Access Compliance Report

Public Rights-of-Way

(Curb Ramps)

Intersection ID: 10017066	Main Street: NEAL_RD	Cross Street: N/A	Location: SE
ADA ID: A9D045730FA3	Ramp Type: PerpDiag	Initial Pass/Fail: Fail	Overall Compliance: No
Severity Score: 13.75			
Codes/Mitigation Info/Possible Solution		Field Measurements/Component Compliance

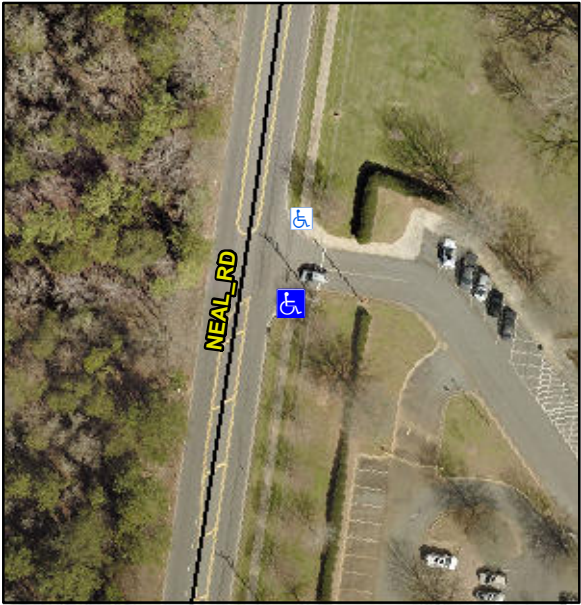
Possible Solutions:		Compliance	Description	Data	Compliance	Description	Data
	Remove & Replace Curb Ramp With Two New Directional Ramps or Equivalent.		N/A	Ramp Length (in)	134.0	No	Ramp Slope (%)	8.9
<p>Surveyor Notes:</p> <p>N/A</p> <p>PROW/ADA:</p> <p>Not Found, R304.2.2, R304.5.3</p>			Yes	Ramp Width (in)	49.0	No	Ramp XSlope (%)	2.7
			N/A	Flare Type LT	N/A	N/A	Flare Type RT	N/A
			N/A	Flare Slope LT (%)	N/A	N/A	Flare Slope RT (%)	N/A
			N/A	Flare Traversable LT?	N/A	N/A	Flare Traversable RT?	N/A
			N/A	Landing Length (in)	N/A	N/A	DWS Provided?	N/A
			N/A	Landing Width (in)	N/A	N/A	DWS Contrast?	N/A
			N/A	Landing Slope (%)	N/A	N/A	DWS Length (in)	N/A
			N/A	Landing X Slope (%)	N/A	N/A	DWS Full Width?	N/A
			N/A	Landing Curb? (Y/N)	N/A	N/A	DWS Offset (in)	N/A
			N/A	Shared Landing?	N/A			
			N/A	Gutter Ponding?	N/A	N/A	Gutter Slope (%)	N/A
			N/A	Gutter Lip Ht (in)	N/A	N/A	Gutter X Slope (%)	N/A
			N/A	Painted X Walk1?	No	N/A	Painted X Walk2?	No

X Walk 1 Direction	To N		X Walk 2 Direction	To W
			N/A	X Walk 1 Width (in)	N/A	N/A	X Walk 2 Width (in)	N/A
				X Walk 1 Slope (%)	5.1		X Walk 2 Slope (%)	2.9
				X Walk 1 X Slope (%)	4.1		X Walk 2 X Slope (%)	3.8
			N/A	Ramp inside XWalk1?	N/A	N/A	Ramp inside XWalk2?	N/A
				Road Slope (%)	3.6	N/A	Clear Space?	N/A
				Road X Slope (%)	1.1	N/A	Clear Space to XWalk (in)	N/A
			N/A	Any Obstructions?	N/A	N/A	Storm Grate/Utility Hazard?	N/A
				Obstruction Type			Storm Grate/Utility Type	
						N/A		N/A
						Yes	Surface Condition? (G/P)	Good
